**Lynn Lake Gold Project
Environmental Impact Statement**

**Federal IR Responses Round 4
Final Submission**

RESPONSE TO IAAC-R4-01

Map No.
IAAC-R4-01-1

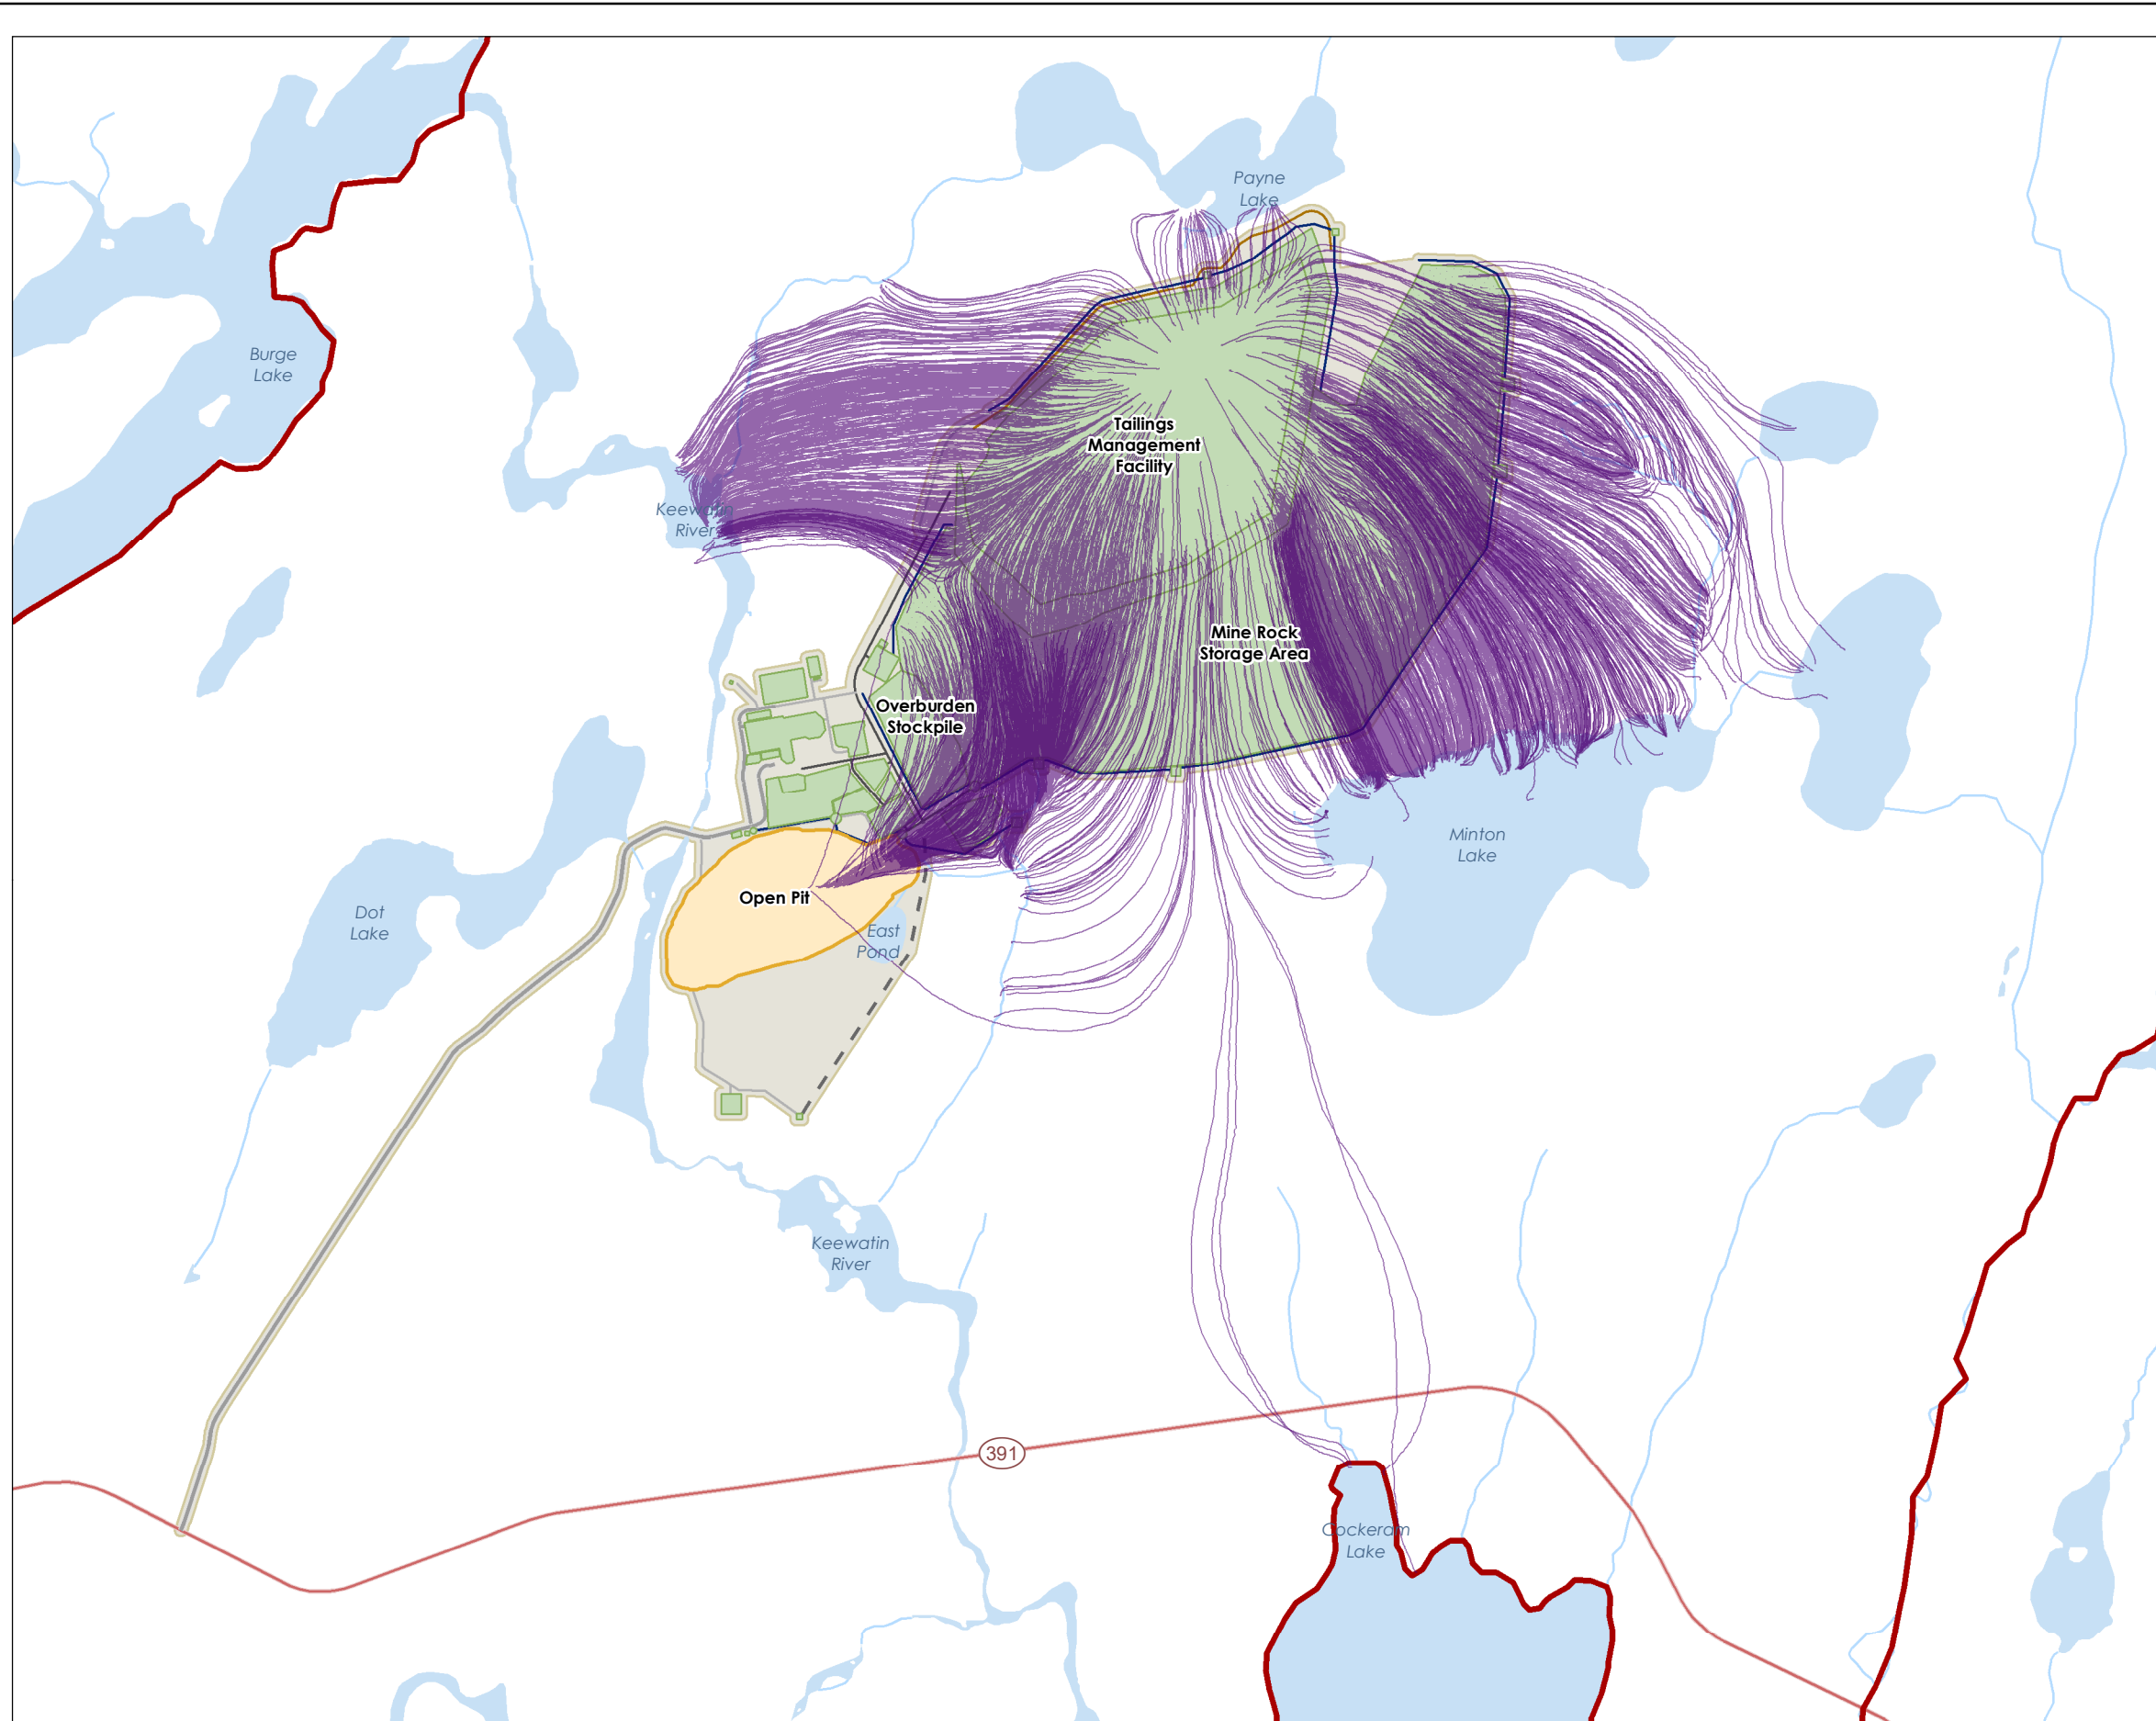
Information Request:	<ol style="list-style-type: none"> a. Provide the results of an updated calibrated groundwater model using a uniform hydraulic conductivity for all bedrock units more than 50 metres below the top of bedrock for the MacLellan site, to represent a conservative scenario for the groundwater assessment relative to baseline. b. Compare the results of the updated model referred to in a) with the original modelling results presented in response to IAAC-R3-01 and clearly describe any differences in the amount, timing, and location of groundwater discharges to surface water features. c. Provide an updated assessment of potential Project effects, including residual and cumulative effects, for all relevant VCs to account for any changes identified in question b. Include a description of any changes to the predicted residual

ID:	IAAC-R4-01
	<ul style="list-style-type: none"> - Map IAAC-R4-01-1: Particle tracks from TMF and MRSA for the sensitivity scenario. <p>b. It was not entirely clear what was requested as part of the IAAC-R3-01 sensitivity scenario and so the hydraulic conductivity of the intermediate and deep bedrock layer was modelled in the IAAC-R3-01 sensitivity scenario as an order of magnitude greater than that estimated based on field data. As stated in the response to IAAC-R3-01, this sensitivity model run for IAAC-R3-01 is not reflective of the field characterization of the MacLellan site and the results contrast with the conceptual model of hydrogeology for the site. Accordingly, the results of this IAAC-R4-01 new sensitivity scenario requested are not compared with the sensitivity scenario presented in IAAC-R3-01, but instead compared only with the base case result.</p> <p>With a uniform hydraulic conductivity of the intermediate and deep bedrock model layers, groundwater flows further into the intermediate and regional flow systems (intermediate and deep bedrock model layers) as opposed to flowing through the local or shallow bedrock system and discharging to nearby surface water features as in the base case. The total groundwater seepage to the receiving environment (surface water), as presented in Table IAAC-R4-01-2, decreased compared with the base case, which indicates that more recharge from the TMF and MRSA is not predicted to discharge to surface water, rather the discharge flows to the intermediate and deep bedrock.</p> <p>Note the travel times in Table IAAC-R4-01-2 for the base case are different than that previously reported. The travel times previously reported appear to have been originally extracted as days but reported in years, along with other minor post-processing errors. The corrected travel times for the base case in Table IAAC-R4-01-2 are similar to those for sensitivity scenario 1.</p> <p>Regardless of the reduced travel times, the assessment of effects of groundwater discharge to surface water was completed using total groundwater discharge, did not include travel time, and conservatively assumed groundwater seepage from mine features arrived at receptors instantaneously. Consequently, travel time did not influence the assessment of effects for groundwater or other relevant VCs.</p> <p>In addition, Alamos has committed in the Environmental Impact Statement, with additional details provided through a series of Information Request responses (specifically IAAC-62, IAAC-108, IAAC-R2-02, IAAC-R2-12, IAAC-R2-Appendix 20B, IAAC-R2-77), a Groundwater Management and Monitoring Plan that will be in place following Project approval that includes monitoring of potential seepage from mine infrastructure. Alamos' commitment includes:</p> <ul style="list-style-type: none"> - Installation of a series of monitoring well fences to account for different travel times of seepage from the mine infrastructure. For example, monitoring wells immediately downgradient of the MRSA/TMF to understand source seepage concentrations, with monitoring wells at a series of downgradient distances from the source to confirm groundwater flow pathways and travel times. - Water quality sampling at a frequency that will account for the range of travel times predicted through the groundwater flow modelling. - An adaptive management plan with a series of thresholds that will alert Alamos to changing conditions in groundwater that have the potential to affect surface water and the associated aquatic biota and/or wetlands. The trigger
